Preliminary Site Development Plans
for
Valley West Shopping Center
Bloomington, Minnesota

Project
**VALLEY WEST
SHOPPING
CENTER DEMO**

CASE #PL2020-190

Sheet Title
VEHICLE TURN
EXHIBIT

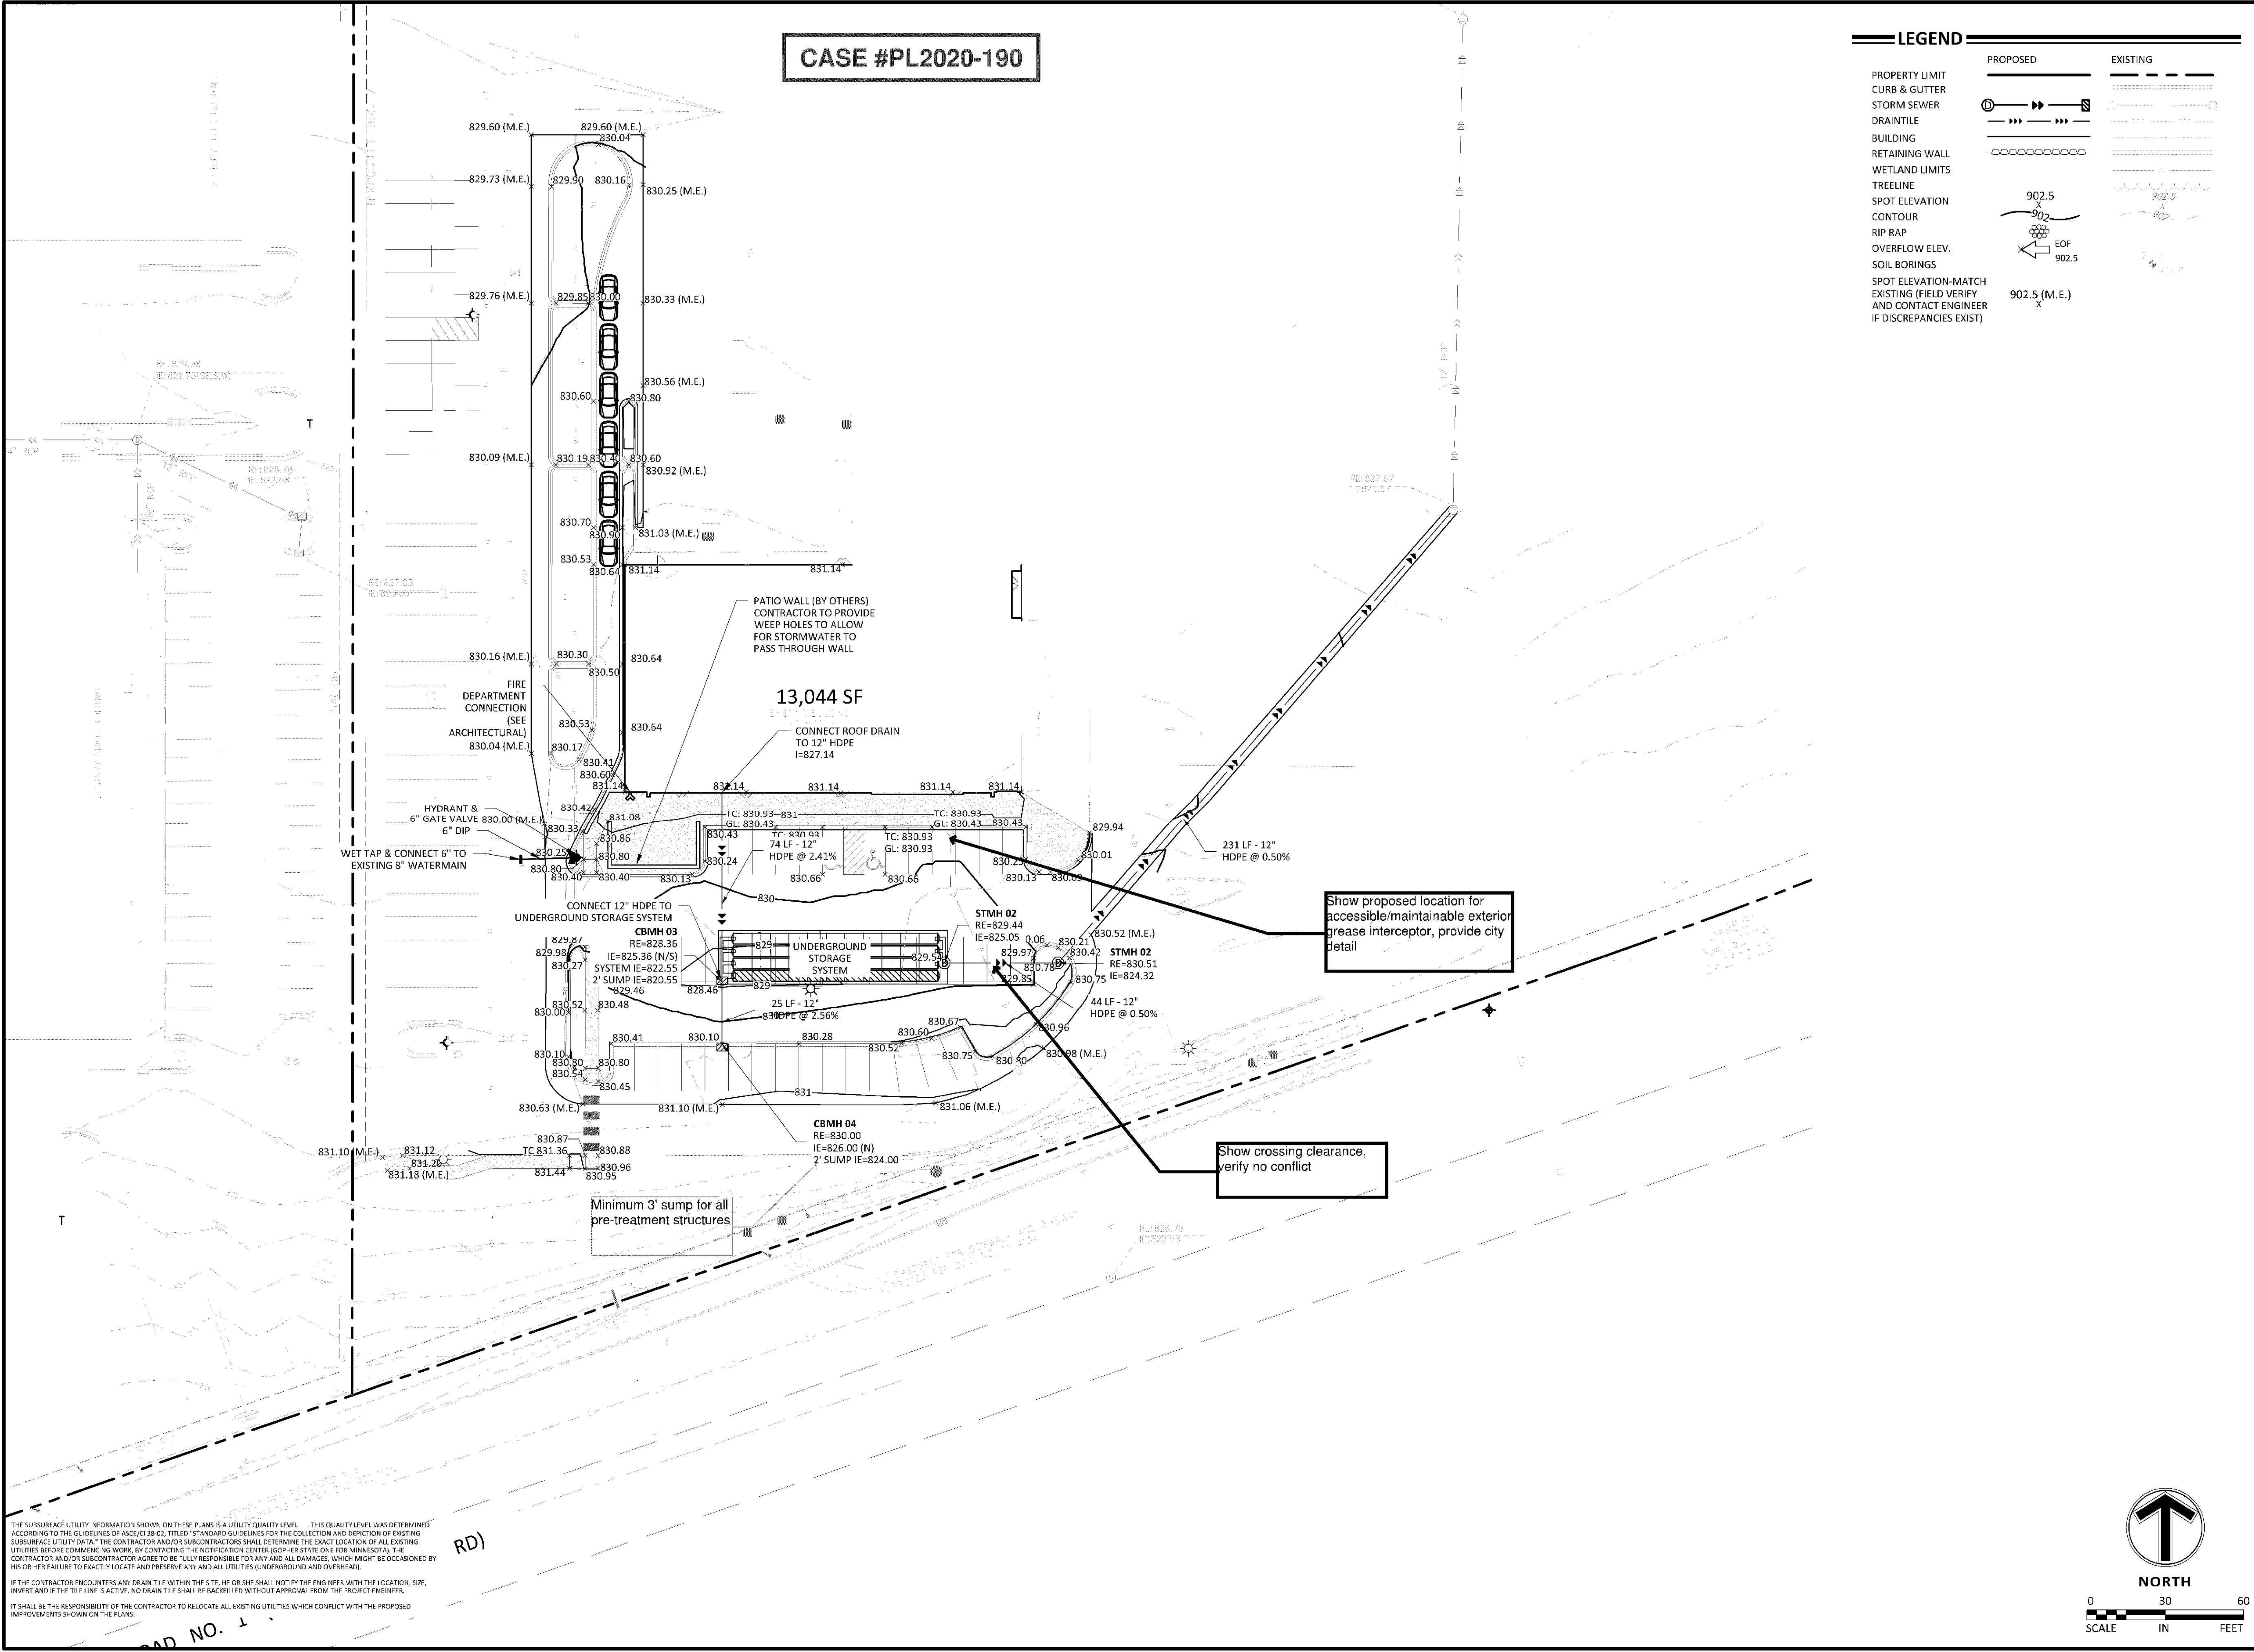
Several hydrants exist in islands/parking area along the west side near the FDC's. Access to the hydrants shall be maintained.

Access to existing FDC locations along the west side shall be maintained. It appears that this configuration may block two or more.
